STATE OF VERMONT
 STATE HIGHWAY DEPARTMENT

PLAN AND PROFILE OF PROPOSED
 STATE HIGHWAY
 FEDERAL AID PROJECT

TOWN OF MANCHESTER
 ROUTE VT 7A

Project No. SN FAP 92CCU

Surveyed by LW Brownell
Designed by LW Brownell
Drawn by LW Brownell
Traced by J.O. Clark
Checked by
Series J.N.F.P. No. 52C.1 F. 44
Sheet 7 of 15 Sheets

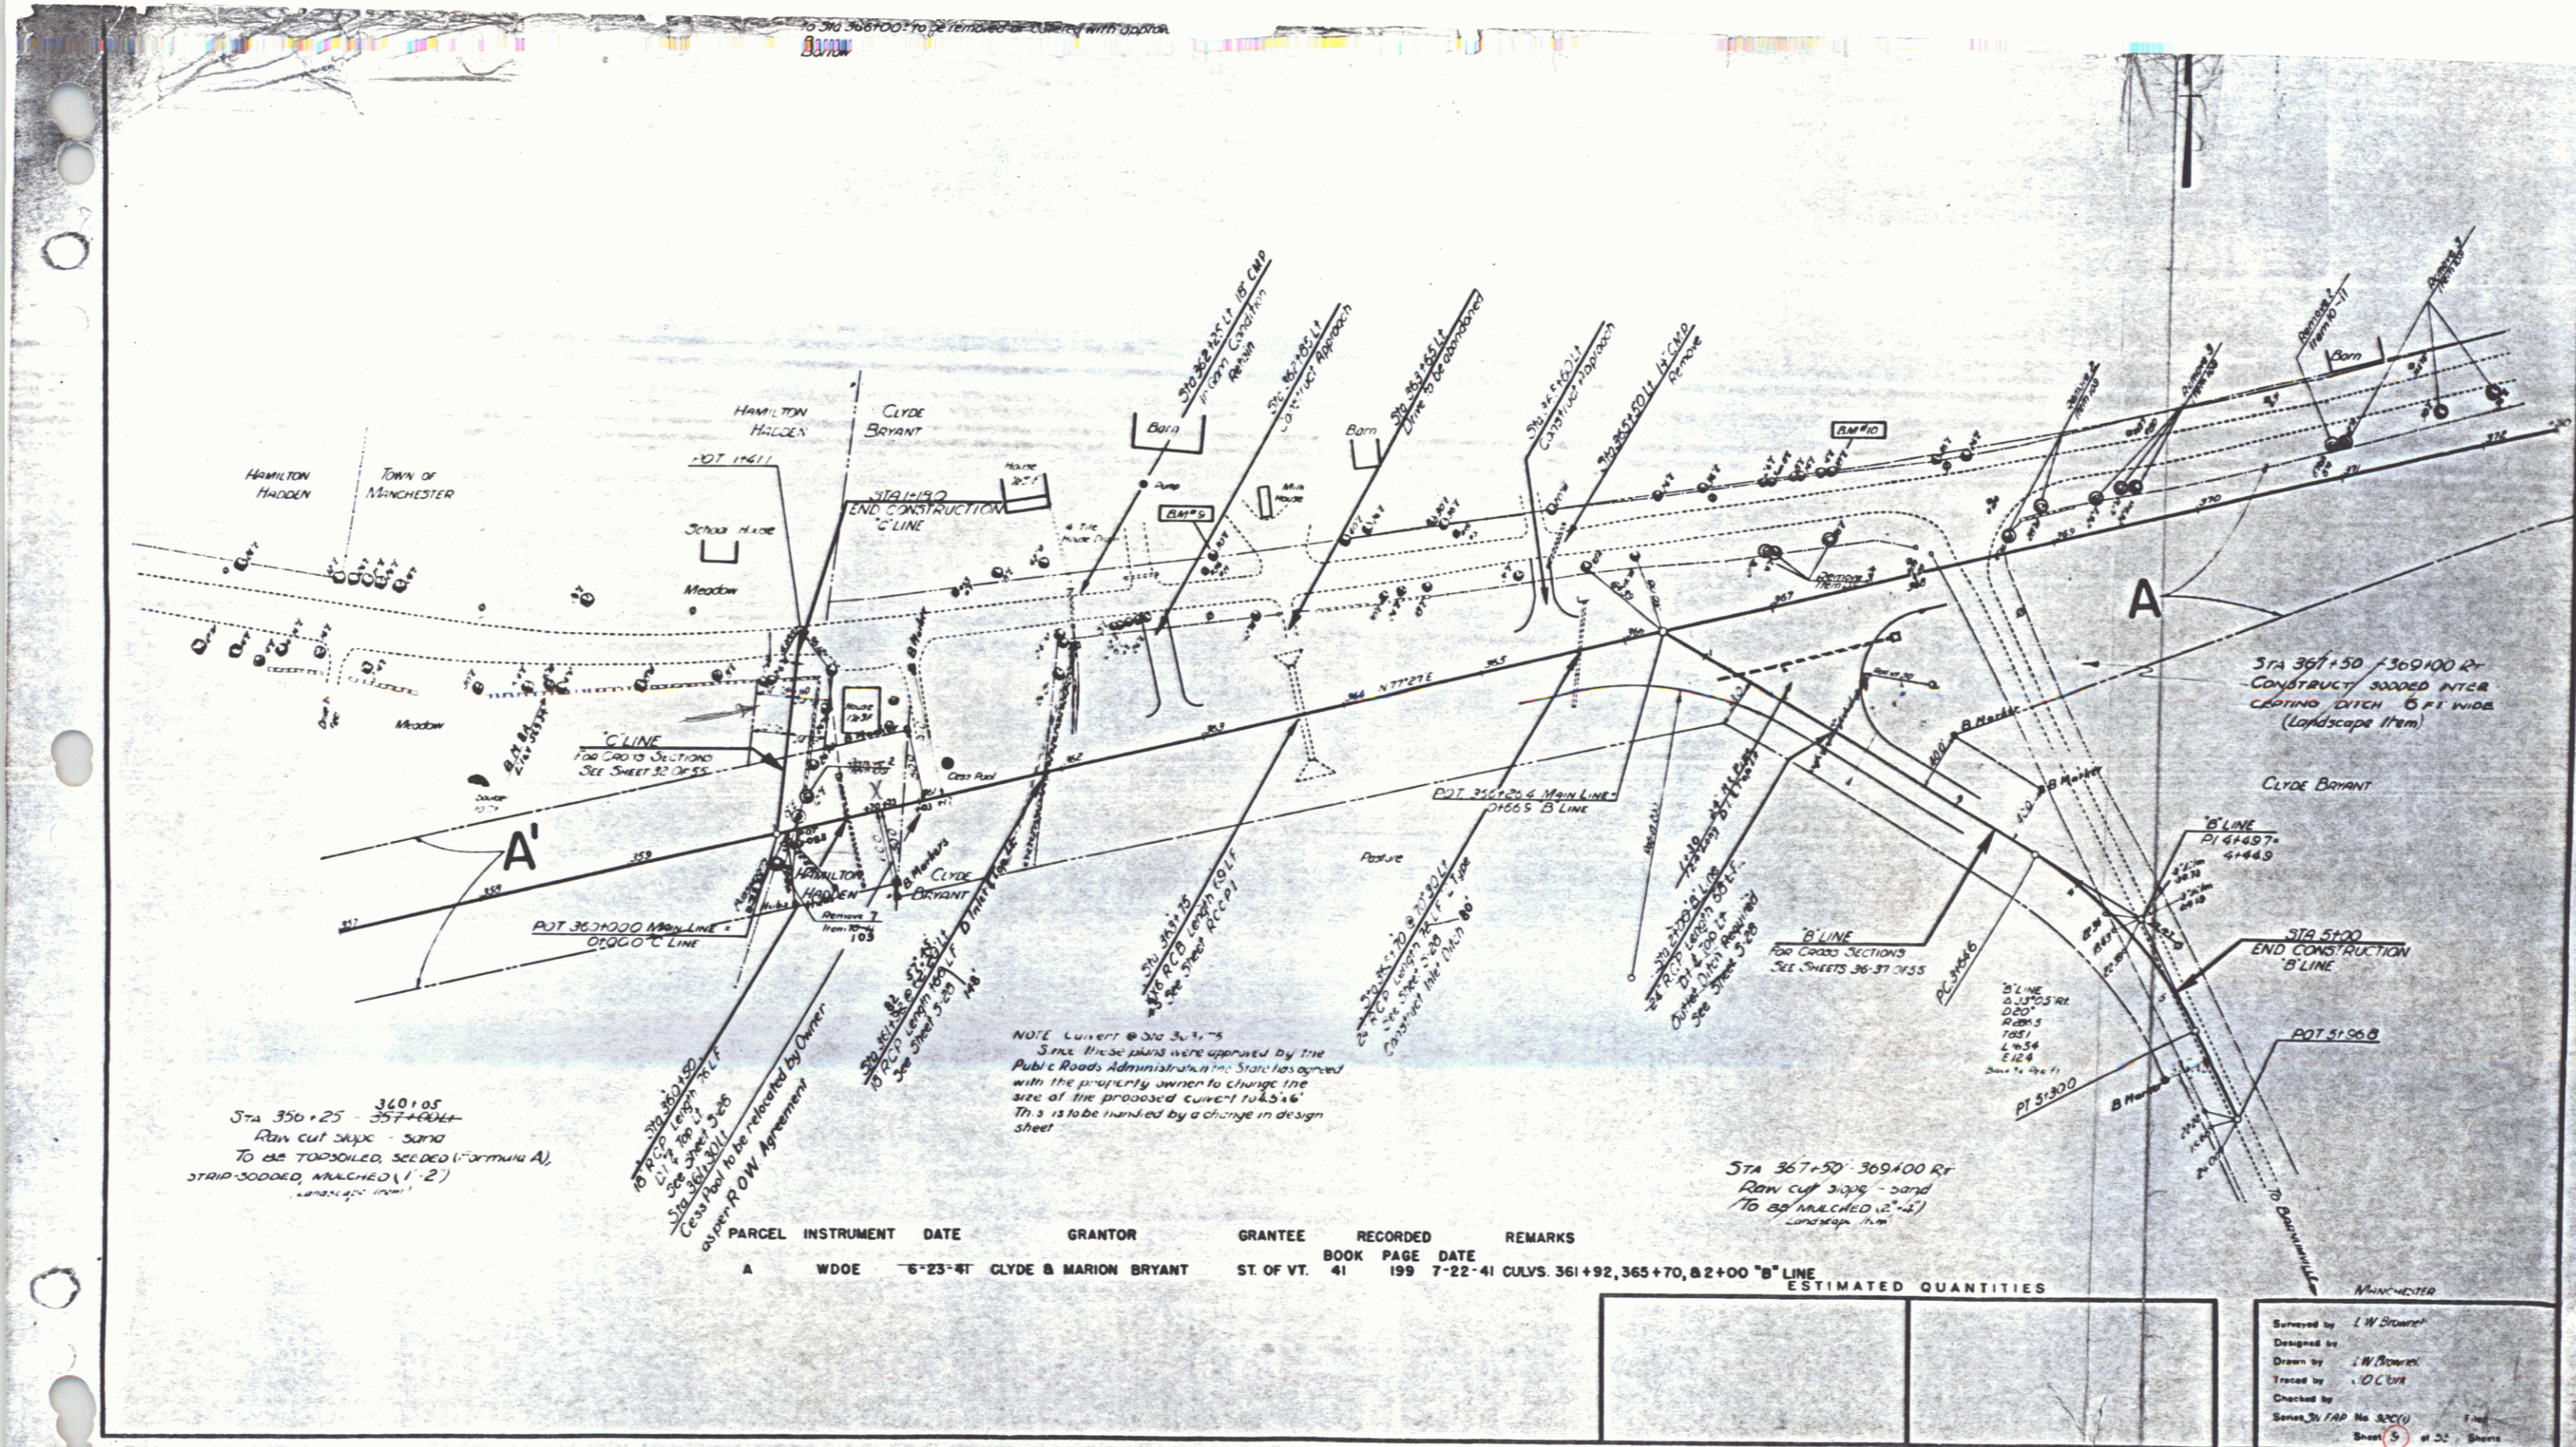
NOTE: Culvert @ Sta 344+00 This culvert added to the plans when they were approved by the public works Administration and the quantities are not included in the plans This to be handled by a change in usgr. etc.

NOTE Culvert @ Sta 363+75
 Since these plans were approved by the
 Public Roads Administration the State has agreed
 with the property owner to change the
 size of the proposed culvert to 48" x 48"
 This is to be handled by a change in design
 sheet

MANUFACTURED
 Entered by L.W. Brown
 Drawn by L.W. Brown
 Traced by C.C. Cole
 Checked by
 Series No. 3200
 Sheet 5 of 25 Sheets

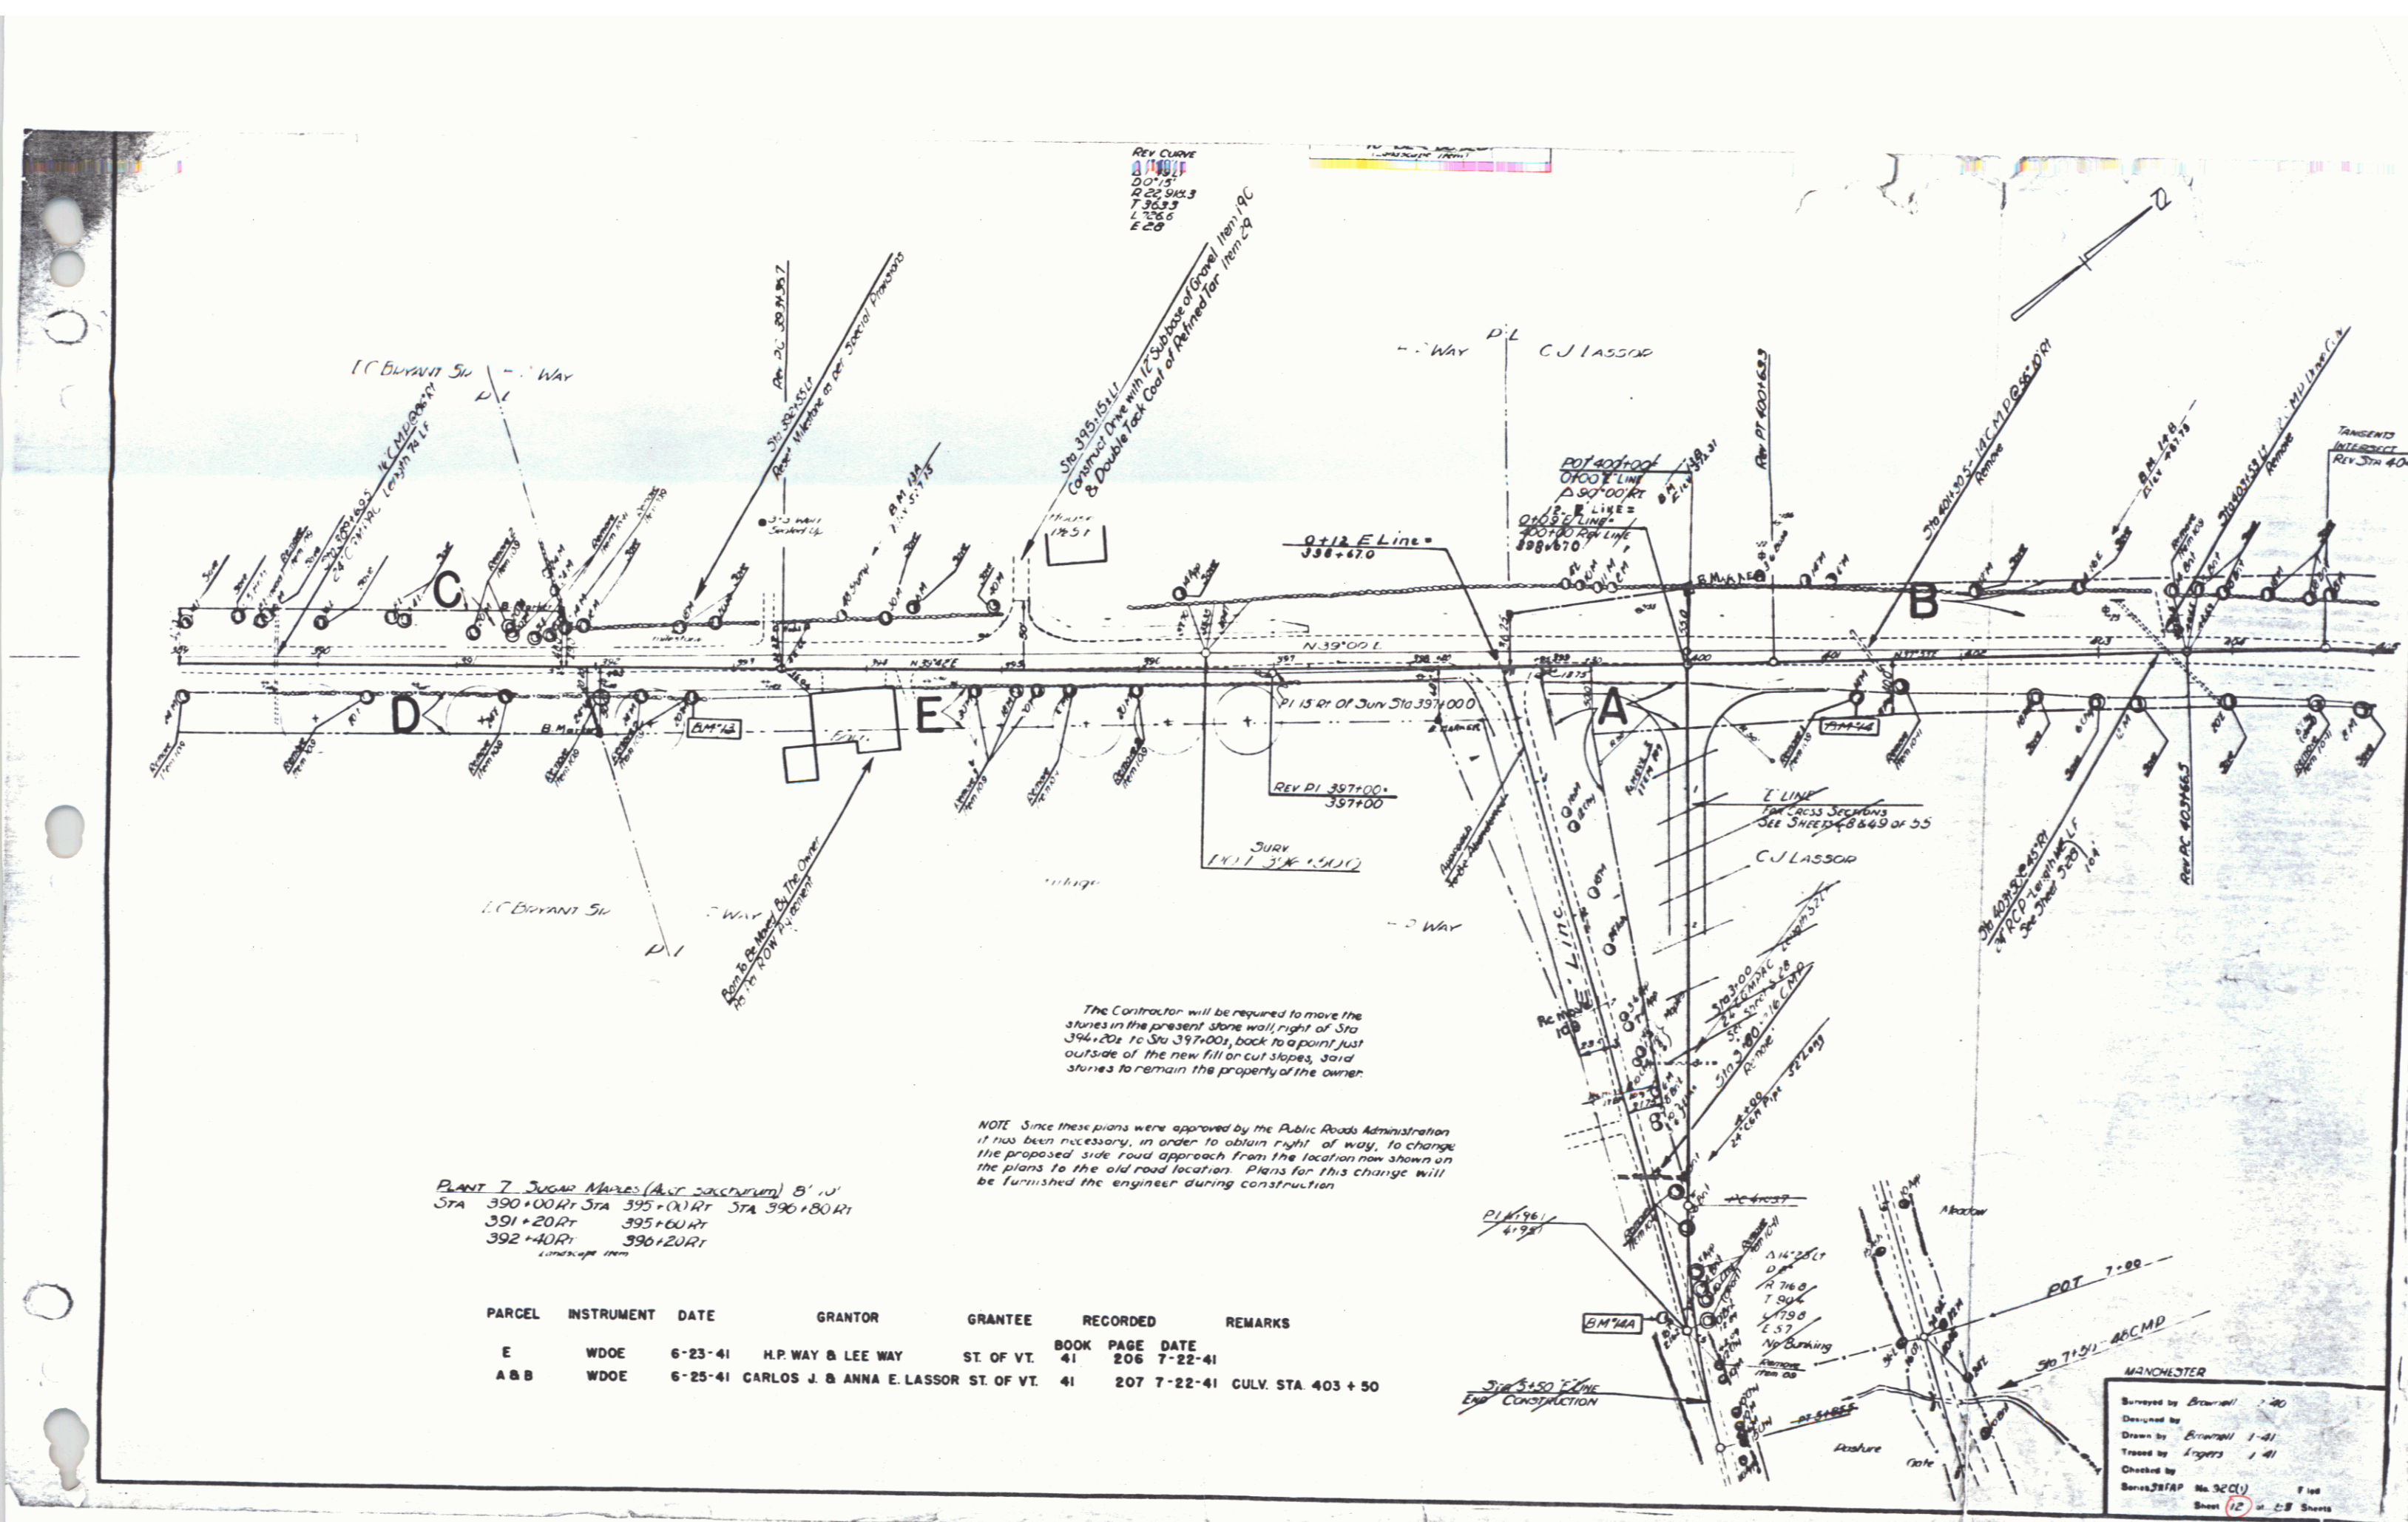
NOTE: Since these plans were approved by the Public Roads Administration it has been necessary, in order to obtain right of way, to change the proposed side road approach from the location now shown on the plans to the old road location. Plans for this change will be furnished the engineer during construction.
